## Product Change Notification / ALAN-05LSYV366

CCB 6137 Initial Notice: Qualification of MMT as an additional assembly site for selected MCP4232xx, MCP4242xx, MCP4262xx, MCP4252xx, MCP4632xx, MCP4642xx, MCP4652xx, MCP4662xx, MCP7383xx, MCP3423xx, and MCP3427xx device families available in 10L DFN (3x3x0.9mm) package.

### PCN# ALAN-05LSYV366

# Pre and Post Change Summary

## NSEB

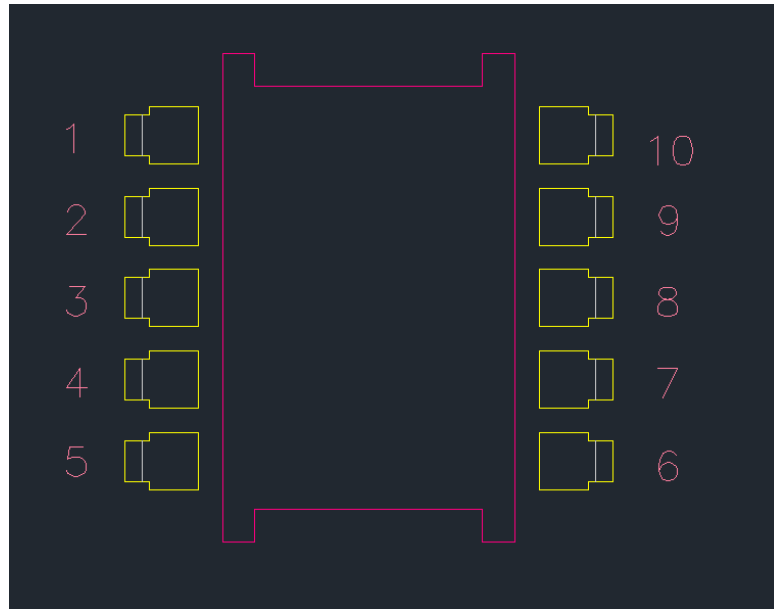
Lead Frame Material	C194
DAP Surface Prep	Bare Cu
Lead-Lock	No

## MMT

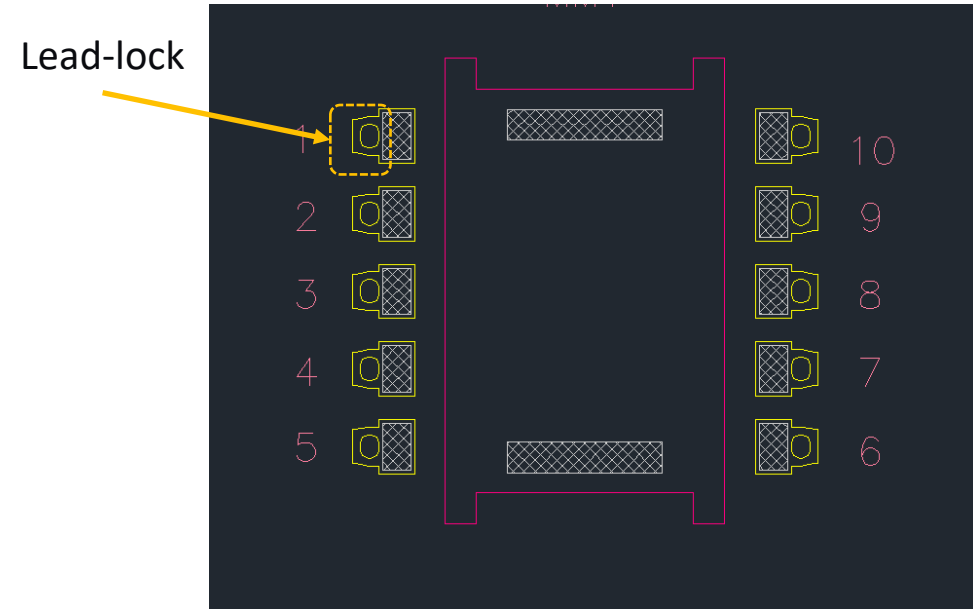
Lead Frame Material	A194
DAP Surface Prep	AG selective
Lead-Lock	Yes
